CUSTOMER NAME :- PAVILION MALL PUNE

SUPPLIER :- NIHVA TECHNOLOGIES PVT LTD

PROJECT NAME :- RETRACTABLE SYSTEM

RETRACTABLE ROOF - THE PAVILION, PUNE

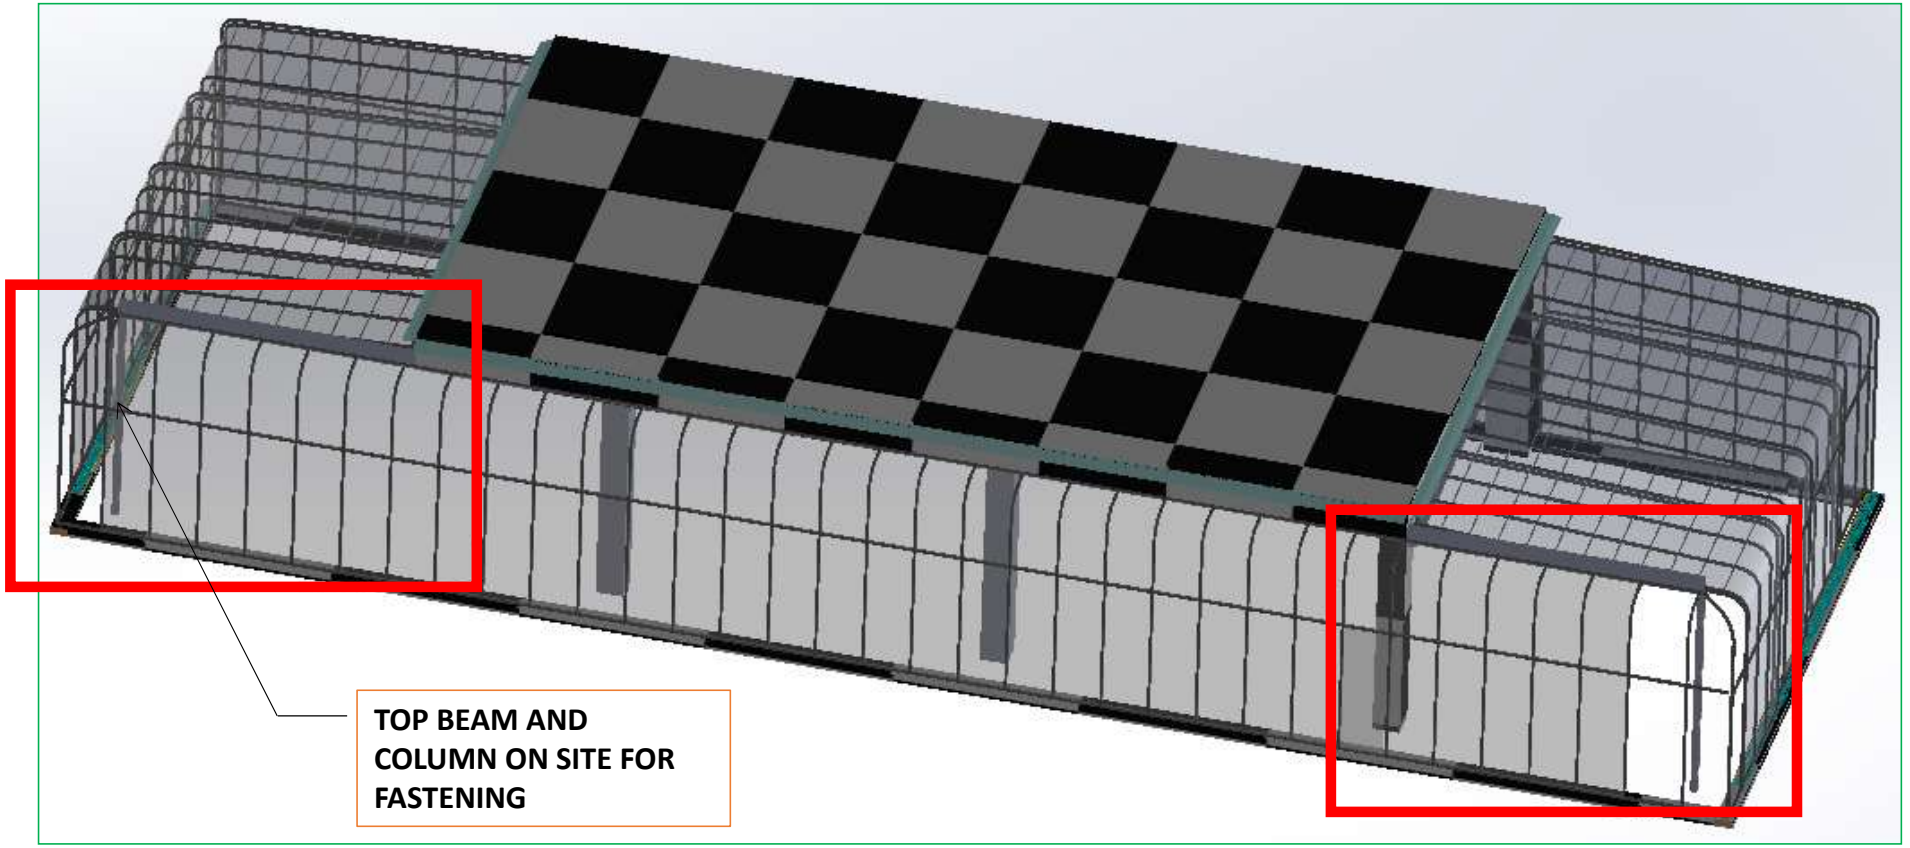
1. The top beam height from the ground is not at one level. Variations are observed from 4877 mm to 5026 mm along the periphery. It needs to be on one level for proper alignment of whole system.
2. On the LH side, there is slope on the floor which needs to be addressed.
3. Bottom concrete block to be constructed for anchoring and fastening for the whole system. It is in client scope.
